## DESIGN REVIEW COMMISSION STAFF REPORT

MEETING: July 6, 2016

SUBJECT: **New Hotel at Wood Hollow  
Design Review Workshop #1  
File: P2015-091; Design Review  
APN 125-202-13 and -14; 7701 Redwood Blvd.**

SITE PLAN

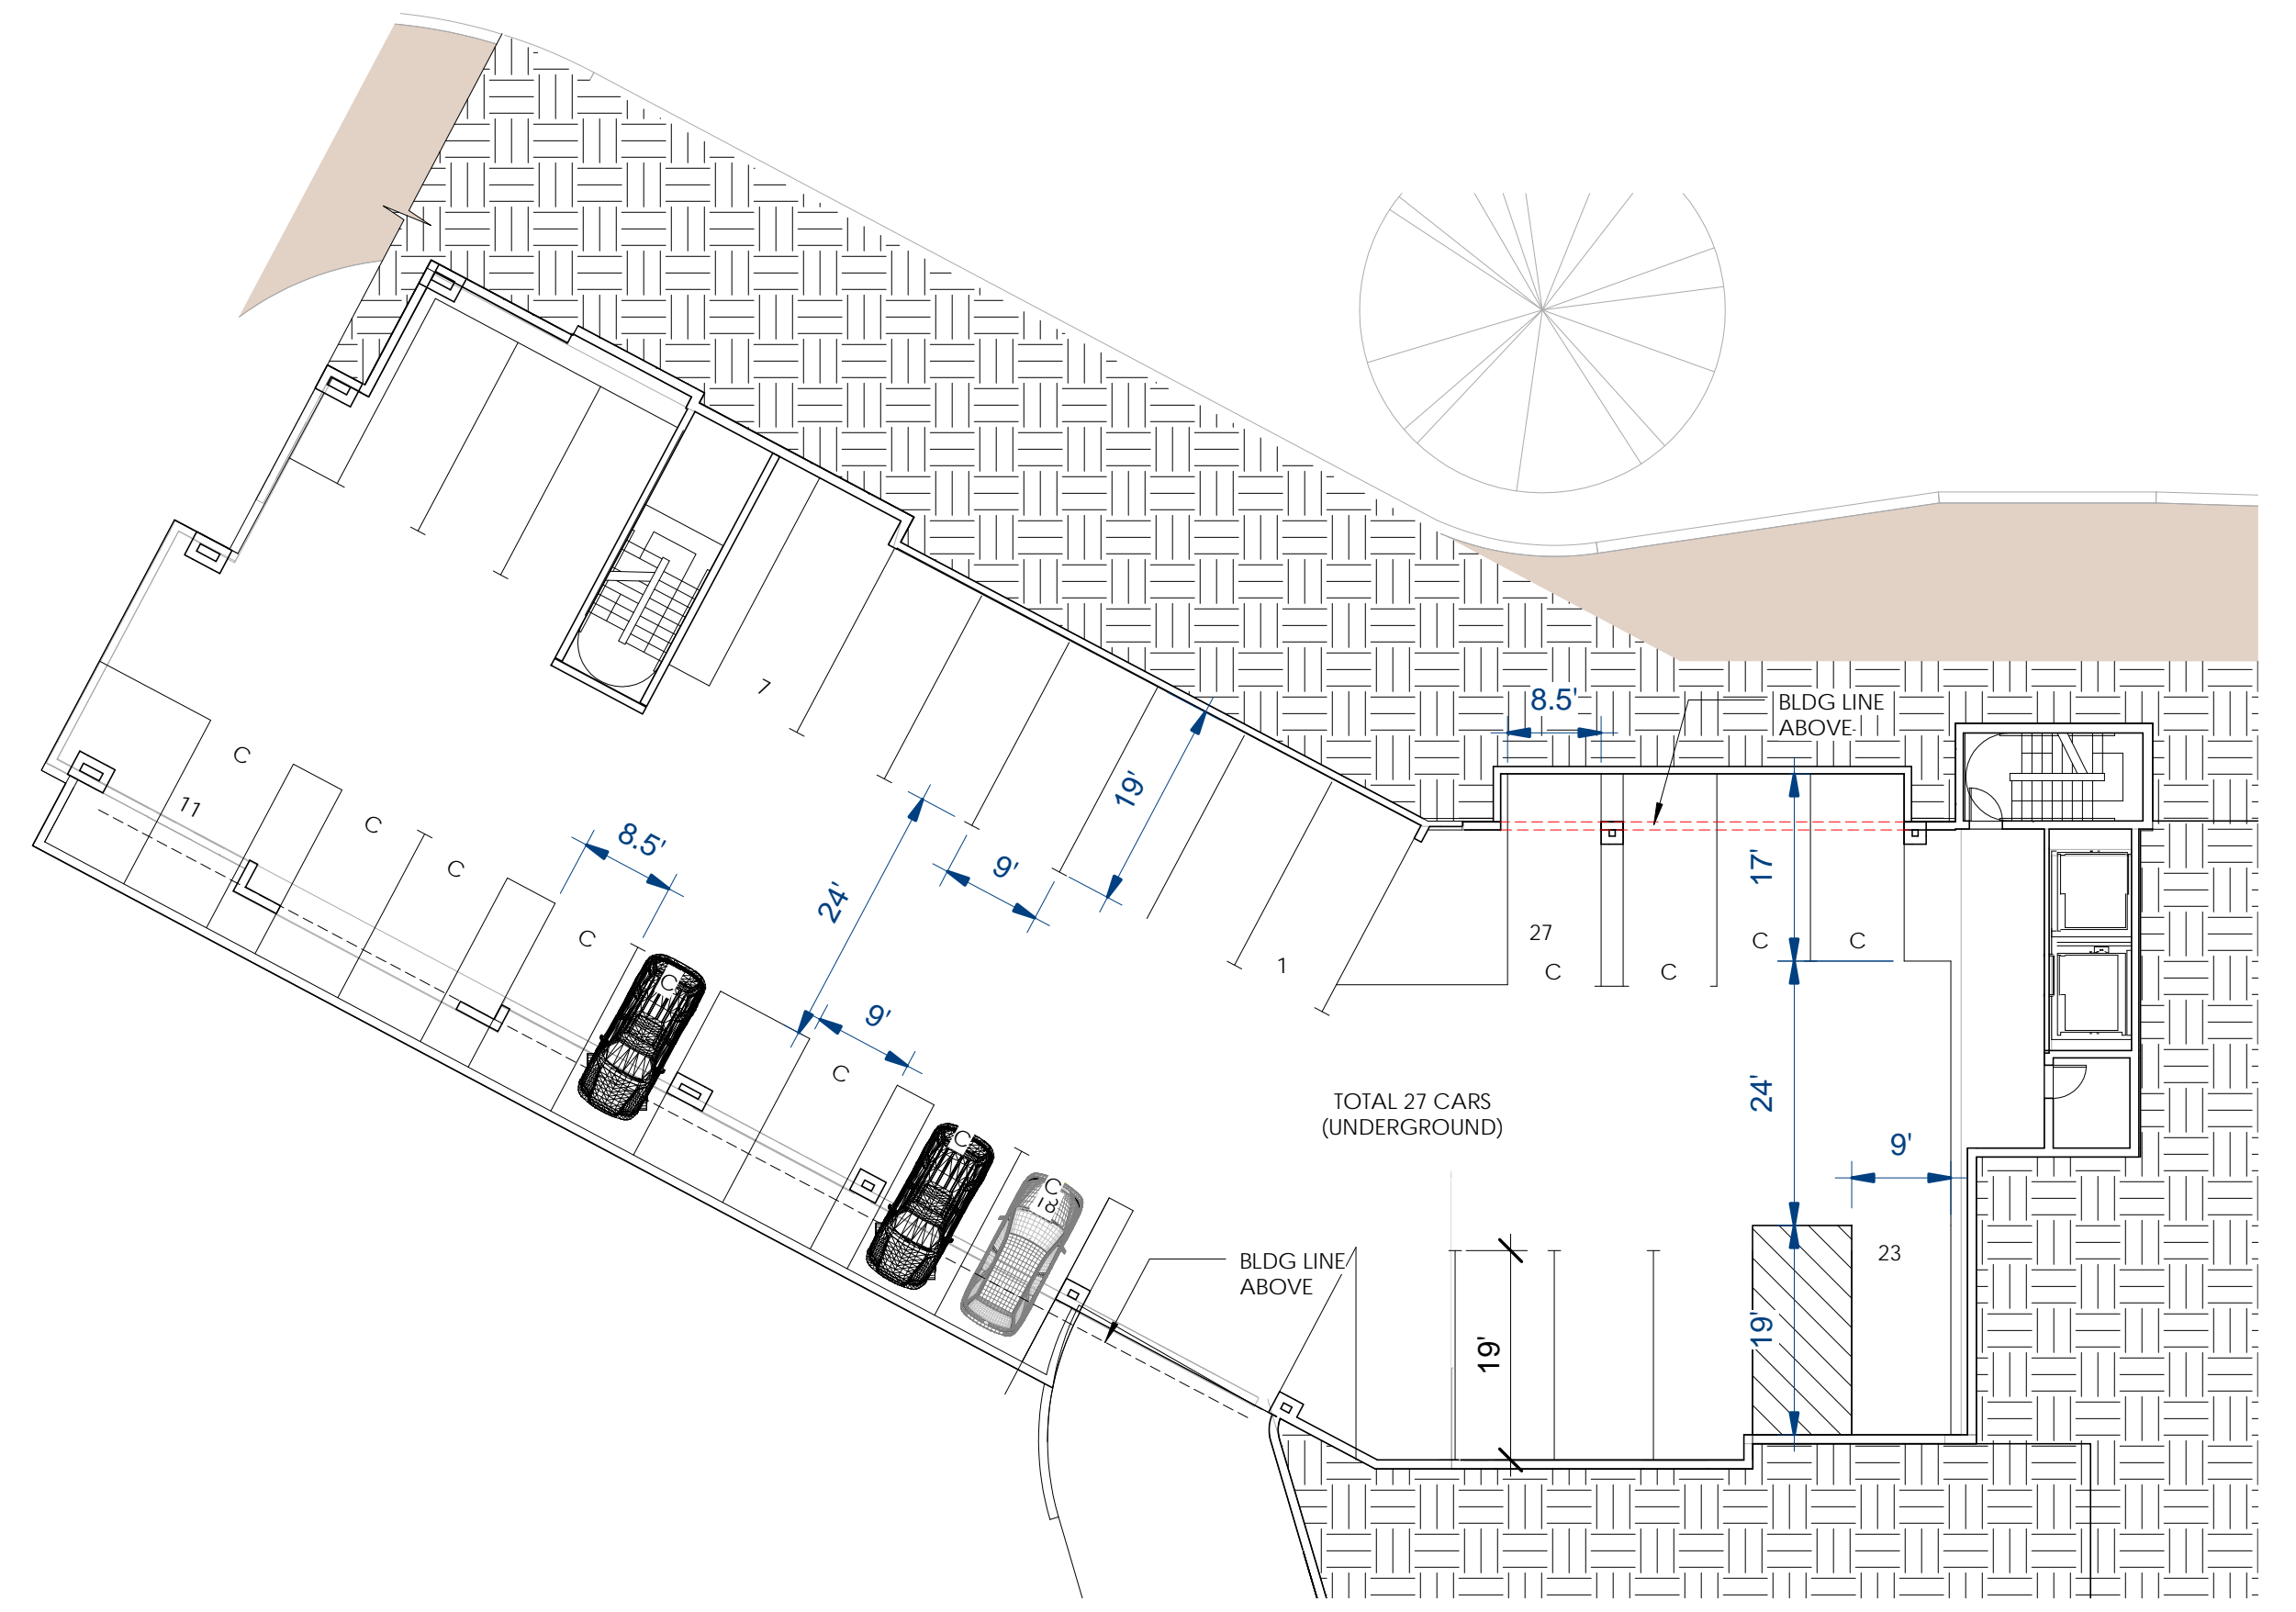
As mentioned in the Project Description, the building has been proposed for the developable portion of the site, bounded on the east by the PG&E Easement, the south by a wetland, and the west and north by slopes with oak trees. The front of the building faces the east, with a parking lot constructed over the PG&E easement and wrapping around the north side of the structure. A retaining wall to the north and west of the building has been proposed to allow the construction of a firetruck access around the west side of the building. The vehicular access/entry to the building is from the Redwood Boulevard frontage, and drops in elevation to the proposed parking lot. A secondary, emergency-only access is shown at the Wood Hollow Drive frontage as required by the Novato Fire Protection District, and will have removable bollards to prevent public access.

parking garage under the building. A retaining wall adjacent to the ramp is proposed to minimize fill within the wetland setback. The retaining wall is not permitted within a 15-foot setback from the PG&E easement, so the applicant is requesting a localized encroachment within the 20-foot wetland setback for a fill slope to accommodate the ramp in this location.

Staff requests that the Commission provide feedback to the applicant regarding the overall approach taken with the site plan, including: context with the surrounding setting, the location/orientation/massing/architecture of the building, on-site circulation, open and basement parking, and ancillary site improvements.

While no trees may be planted within the PG&E easement, the plan includes tree planting along the perimeters of the parking lot, as well as adjacent to the entry drive and the firetruck access.

There was a concern raised about whether the project has enough trees proposed to sufficiently screen the parking lot. The applicant explained that they cannot excavate to plant trees with roots that may encroach on the PG&E pipeline. While planter boxes for trees at the parking lot were discussed, PG&E does not favor improvements such as this within the easement setback, and prefers perimeter trees. In response to the concern, the applicant included perimeter trees at the parking lot. The Commission may consider additional trees for the balance of the parking area. In addition, Staff requests that the Commission consider the opportunity to shift parking stalls 7 through 10 easterly to create a planter island near the walkway at the building outside of the setback from the PG&E easement.

**NOVATO HYATT HOUSE**  
**PRELIMINARY GRADING & DRAINAGE PLAN**

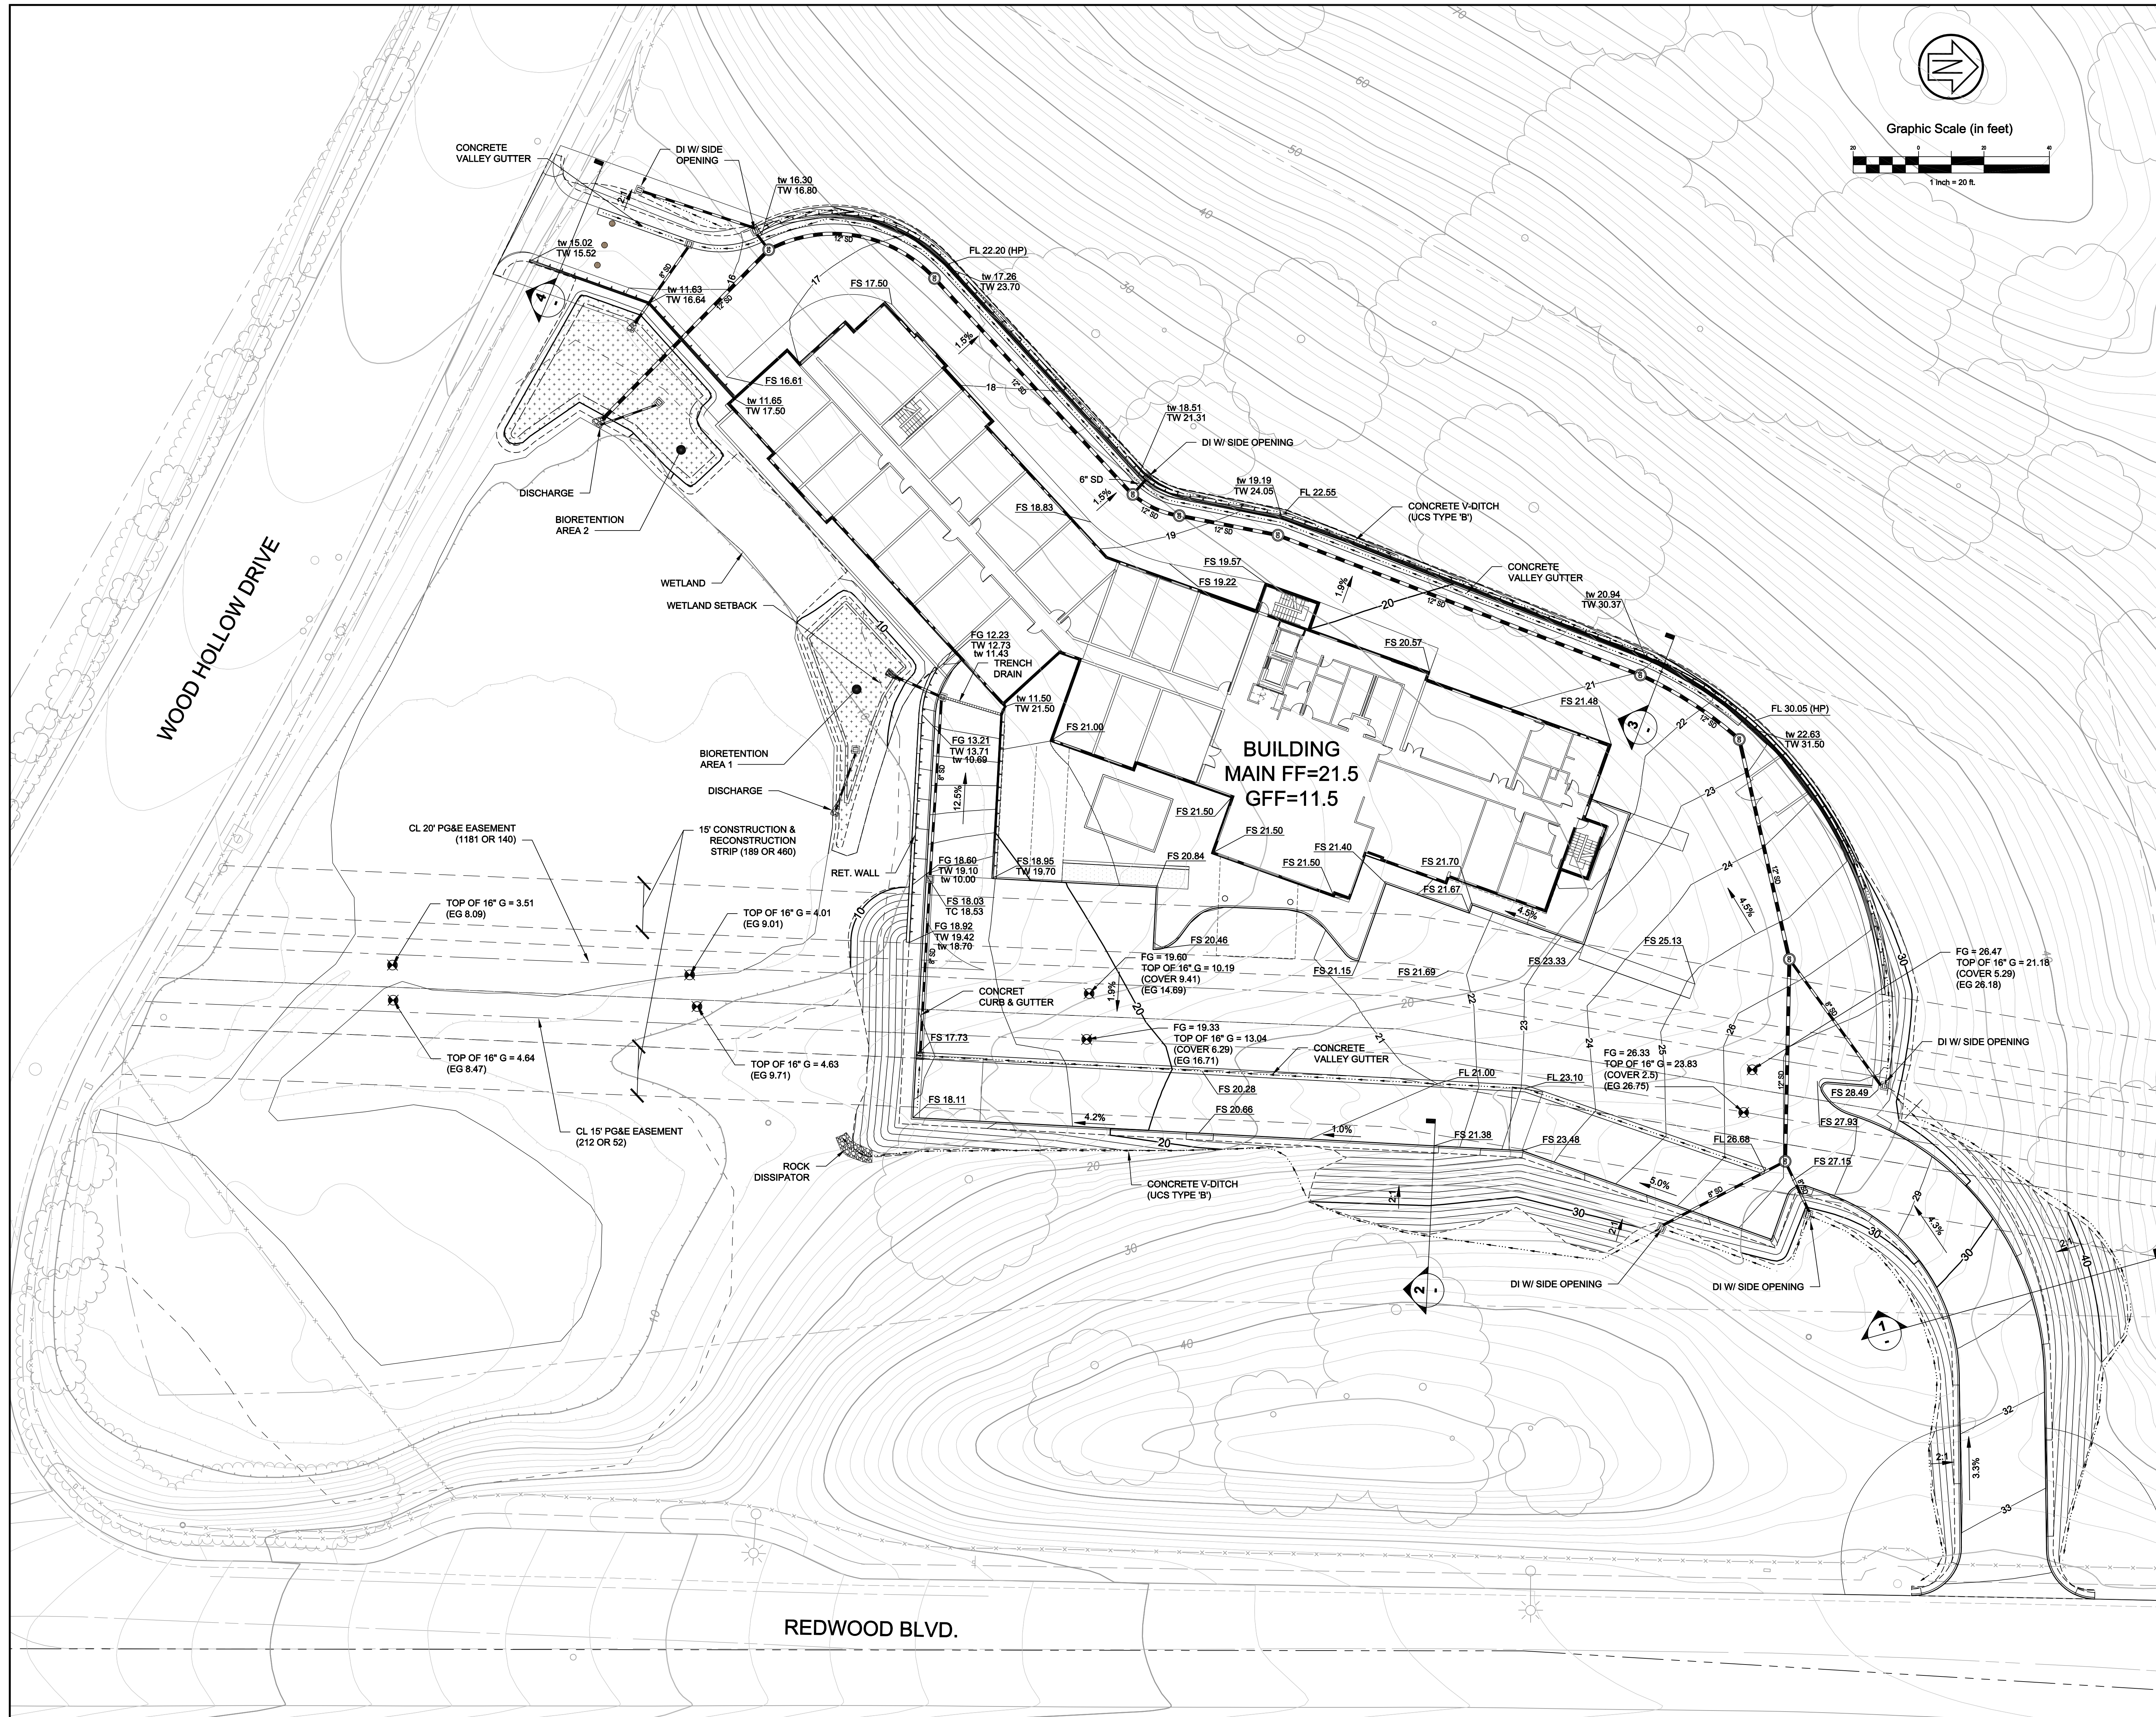
To evaluate the issue of the wetland setback for the proposed hotel, we reviewed the Preliminary Grading and Drainage Plan for the project prepared by CSW Stuber-Stroeh Engineering Group, Inc. dated April 26, 2016 (05/05/16 submittal; 06/14/16 Amended Site Plan & Grading); an exhibit entitled San Marin Business Park, Hydrology Map dated December 19, 2012, and also prepared by CSW Stuber-Stroeh Engineering Group, Inc.; our own files on the original (1999) wetland delineation for the San Marin Business Park site; and other available documents related to the proposed hotel site. In addition we consulted with the project engineers (CSW ST<sup>2</sup>) and visited the site on November 12, 2015, and again on June 29, 2016.

The proposed hotel would not encroach into the delineated wetlands, but would modify the existing hydrology of the site. Most of the natural runoff from the hillsides above the hotel and parking areas would be collected in a perimeter concrete v-ditch above these site improvements and routed via a 12-inch storm drain line into the adjacent wetlands.<sup>1</sup> The discharge for this background runoff would be located at the westerly end (upper sub basin) of the delineated wetlands. Runoff collected from the improved areas of the site would be routed through two bio-retention areas where it would percolate through filtration media before discharge into an underdrain system. High flows that fill the bio-retention areas during major storm events would overflow into the adjacent wetland areas.

The bio-retention areas would be located directly adjacent to the delineated wetlands but all other elements of the project, except for an approximately 200 square foot area of fill within 10 feet of the wetland perimeter, would be located 20 feet from the wetland boundary. As noted above, the bio-retention areas would be allowable within the wetland buffer zone and could potentially be designed to function as an enhancement to the adjacent seasonal wetlands.

Based on our initial review and discussion with CSW ST<sup>2</sup> (Wayne Leach, telephone conversation, 6/28/16), we believe that the drainage plan for the project as described above would preserve the hydrological characteristics of the delineated wetlands on the site and even possibly enhance them. The discharge location for the background (hillside above the project) runoff would be located in what is now a drier part of the delineated wetland area, possibly increasing wetland characteristics in that area. Rather than an energy dissipator at that location, an infiltration gallery might disperse those background flows over a wider area. The bio-retention areas could also be designed with overflow weirs instead of discharge points into the wetlands and the subdrains beneath them could also be routed accordingly.
